March 27, 2013  
Subject: **Fryeburg**  
State WIN: 019726.10  
**Amendment No. 1**

CALDERWOOD ENGINEERING, ETC.  
 STRUCTURAL ENGINEERING • DETAILING SERVICES  
 222 RIVER RD, RICHMOND, ME 04357 PH/FX (207) 737-2007 (207) 737-2008  
 PREPARED FOR:  
**STATE OF MAINE DOT**  
 FRYEBURG, ME SALT SHED  
 WIN 19726.10

**FRYEBURG  
 MAINTENANCE SALT SHED  
 TYPICAL  
 FRAMING DETAILS**

**ROOF DETAIL**  
 2"=1'-0"

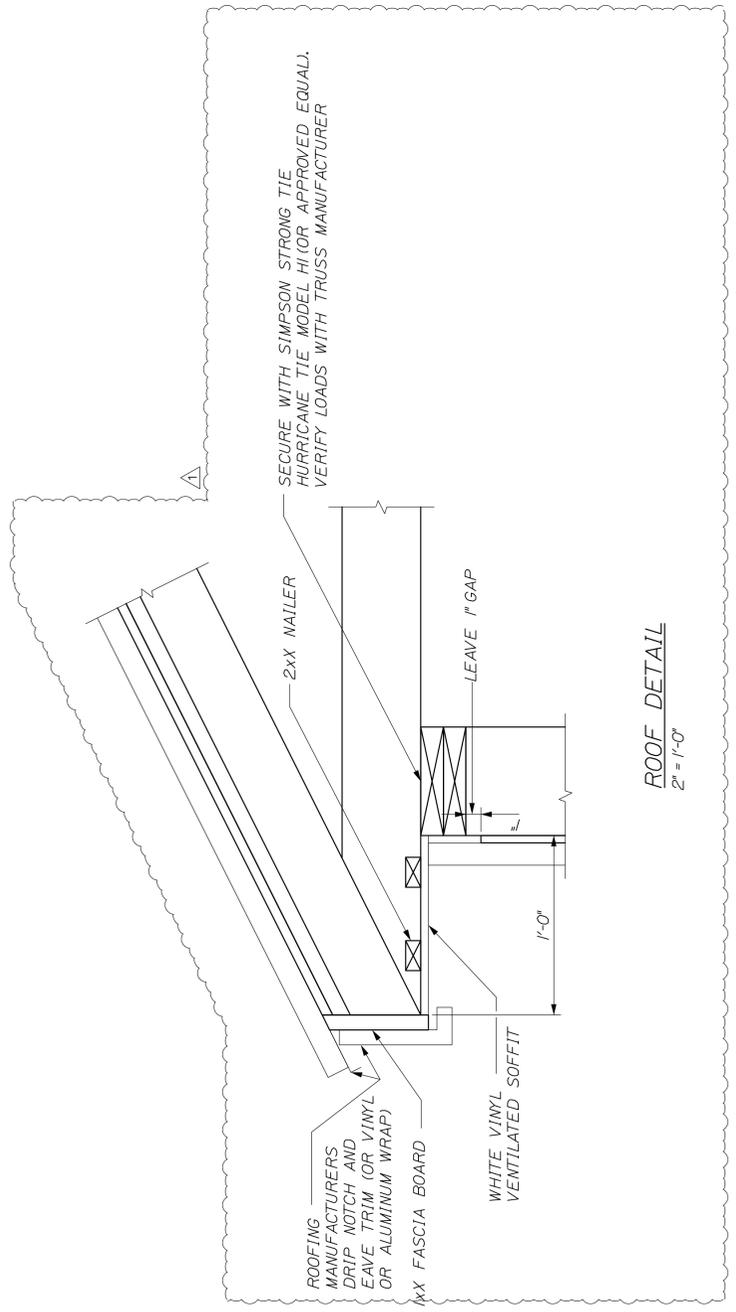
**Question:** Sheet 11; Roof Detail, is there soffit or soffit screening required?

**Response:** Please see revised plan sheet 11 “**TYPICAL FRAMING DETAILS**”, showing the soffit detail under the outlined, “**Roof Detail**”
